April 19, 2024

PROJECT NAME: GREENWAY ESTATES

PROJECT NUMBER: 2023040043

APPLICATION: IMPROVEMENT PLAN #31022

DEVELOPMENT REVIEW COMMITTEE WAIVER REQUEST FORM

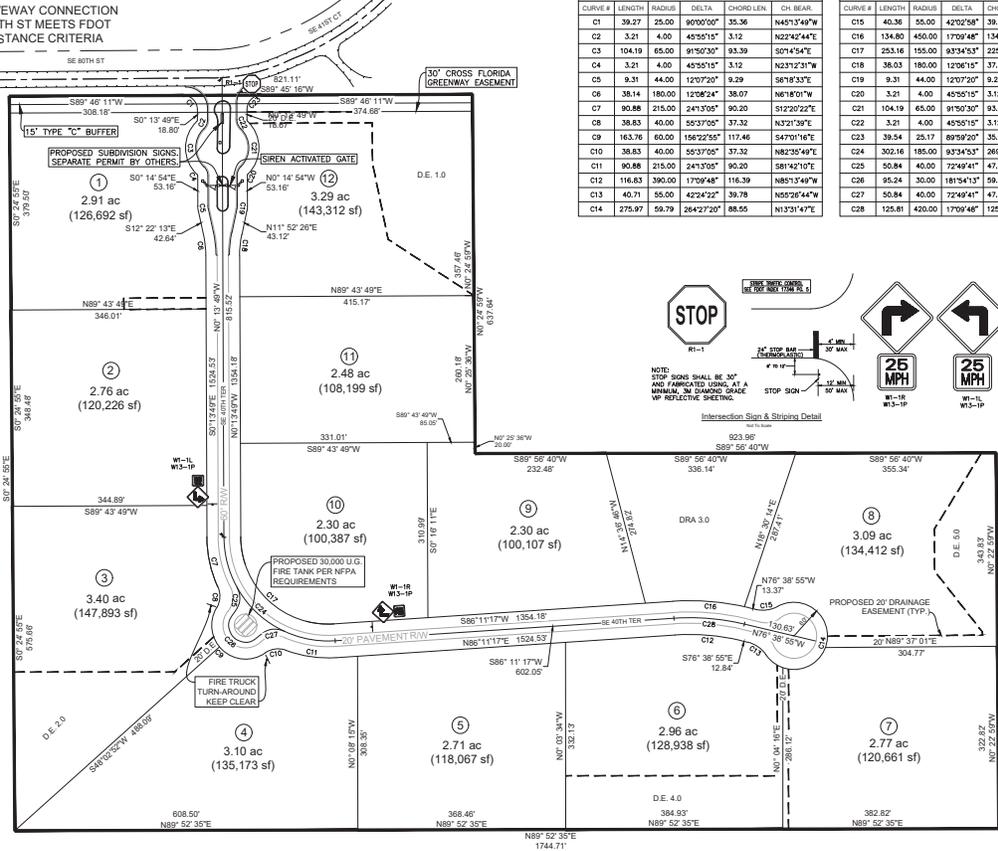
Section & Title of Code (be specific): 6.13.7B(2) - Geotechnical Criteria - Number of Tests
Reason/Justification for Request (be specific): Request waiver to use one soil boring for the small drainage basin 5.0. Soil boring locations were estimated early on in the project and drainage retention requirements were reduced during final design therefore placing the second boring outside of the DRA limits. Soils are well drained sands throughout the site and additional borings are expected to corroborate the same results.
